## P1 Project Drawing Updates - 10/22/2019

### BR-549-A-002

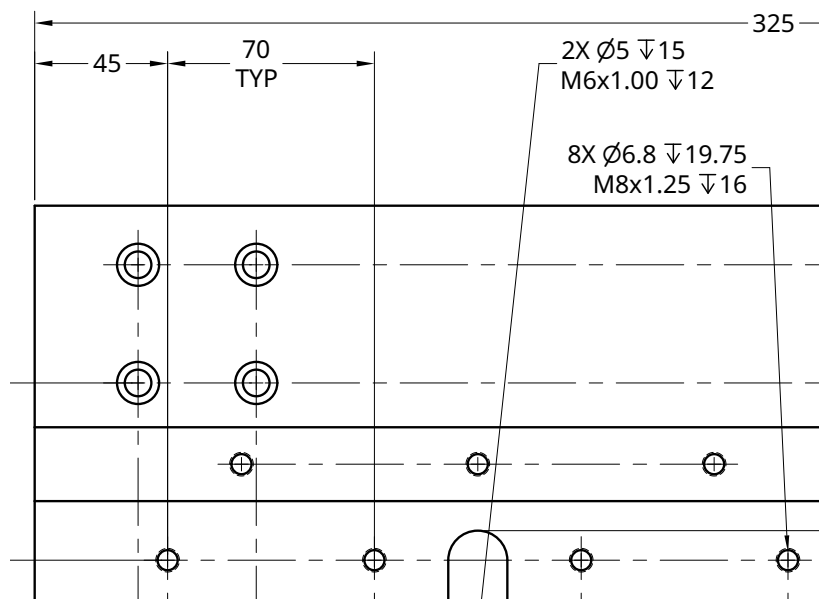
Groove diameter was missing. Also there are 7 (not 6) 0.5 x 45° chamfers.

## BR-549-B-001

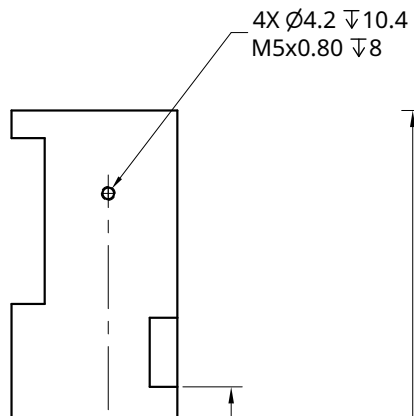
4 holes were missing hole callouts

## BR-549-B-006

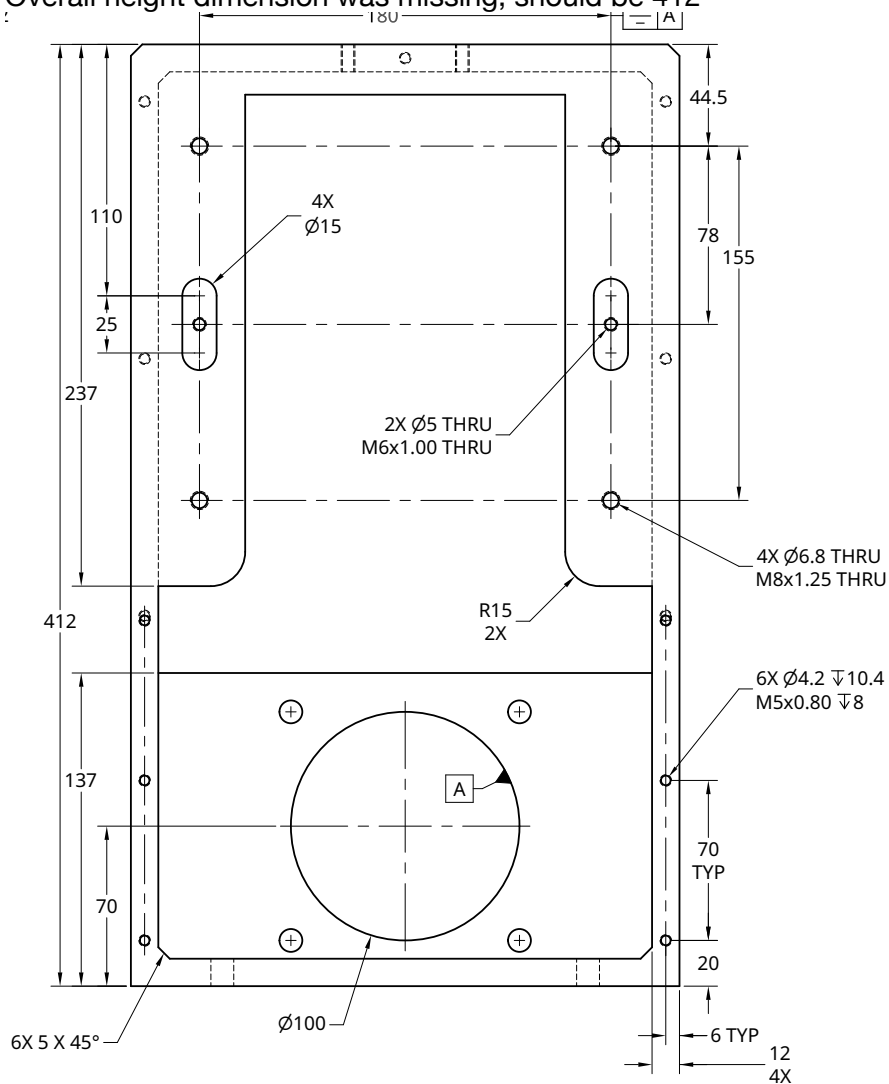
Overall height dimension was missing; should be 412

BR-549-C-001

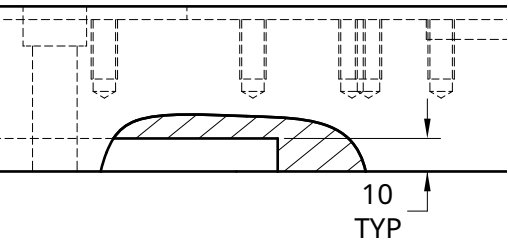
Keyway depth dimension was missing

BR-549-C-003

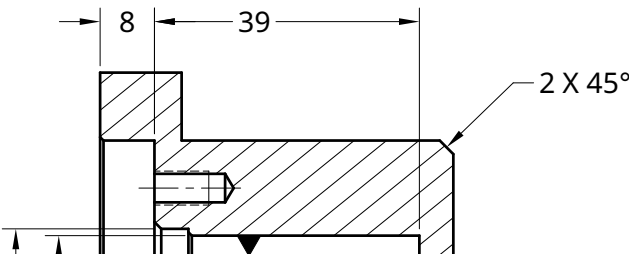
Chamfer dimension was missing

BR-549-C-011

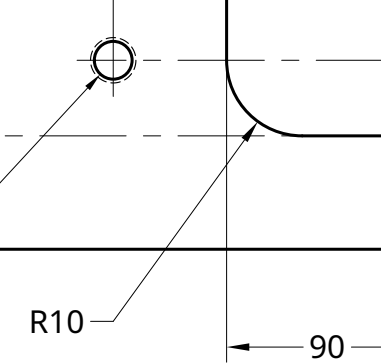
Missing radius dimension
